ISO/IEC
14443-3

Second edition
2011-04-15
AMENDMENT 1
2011-10-15

AMENDMENT 1: Electromagnetic disturbance handling and single-size unique identifier

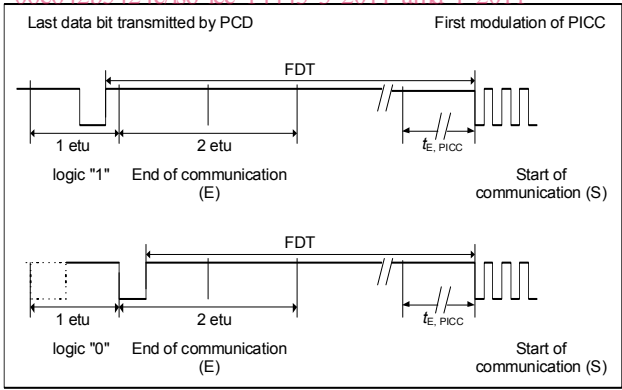
Page 4, Clause 4

Insert the following new symbols between SOF and TR0:

$t_{E,PICC}$ Low EMD time, PICC

$t_{E,PCD}$ Low EMD time, PCD

Figure 17 — Timing before the PICC SOF

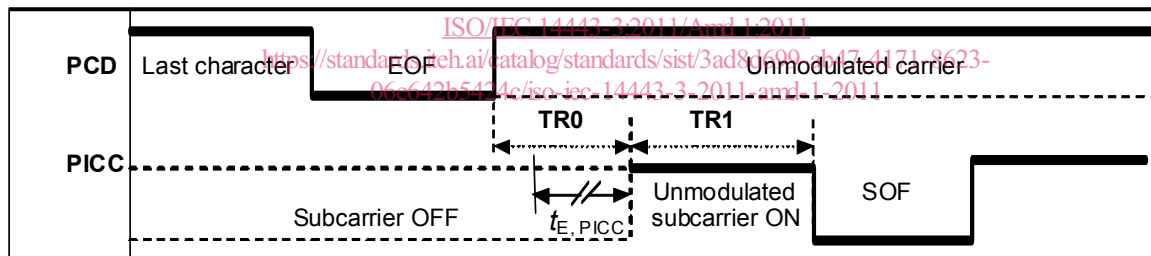
Page 27, 7.1.6

Replace Figure 17 with the following:

NOTE $t_{E,PICC}$ is specified in Clause 8.

Figure 33 — Low EMD time

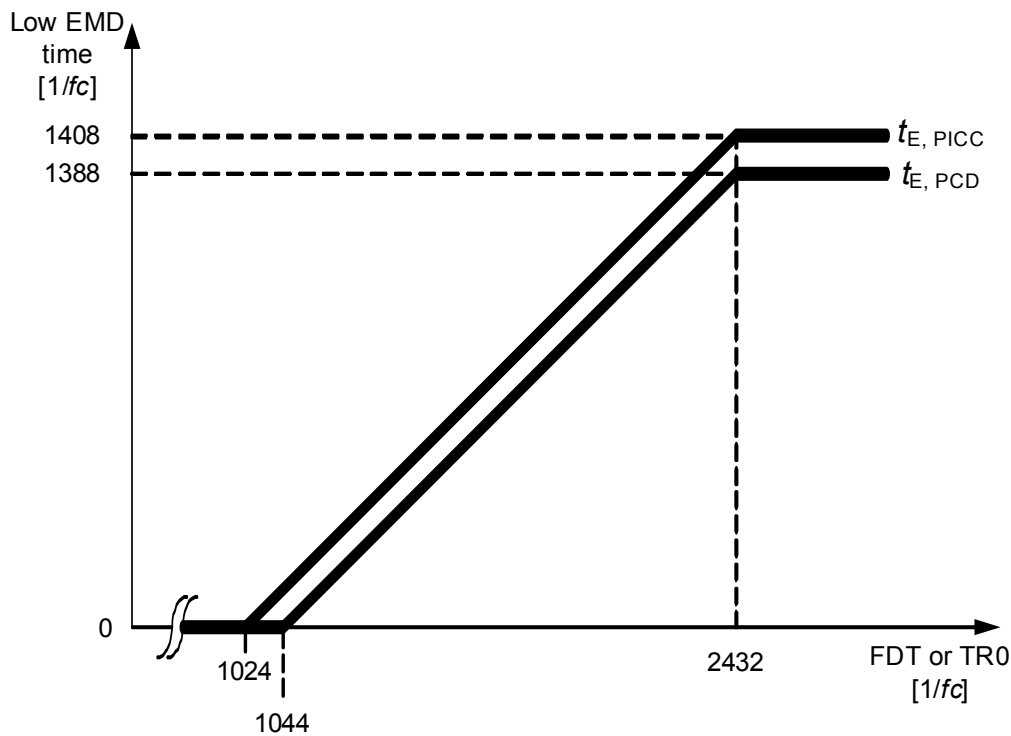
Insert the following new clause after Figure 32:

The low EMD time for PCD and PICC are illustrated in Figure 33.

The low EMD time $t_{E,PICC}$ is the time period before the start of PICC data transmission, when the PICC shall not produce an EMD level higher than the EMD limit as defined in ISO/IEC 14443-2/Amd.1.

This low EMD time $t_{E,PICC}$ has a value of F – 1024/fc with a maximum value of 1408/fc where F equals FDT for Type A and TR0 for Type B. The value is 0/fc for TR0 ≤ 1024/fc.

The low EMD time $t_{E,PCD}$ is the time period to allow the PCD to recover from electromagnetic disturbances.

The PCD shall be ready to process a PICC frame no later than $t_{E,PCD}$ after the last time the EMD level was above the EMD limit as defined in ISO/IEC 14443-2/Amd.1.

This low EMD time $t_{E,PCD}$ has a value of F – 1044/fc with a maximum value of 1388/fc where F equals FDT for Type A and TR0 for Type B. The value is 0/fc for TR0 ≤ 1044/fc.
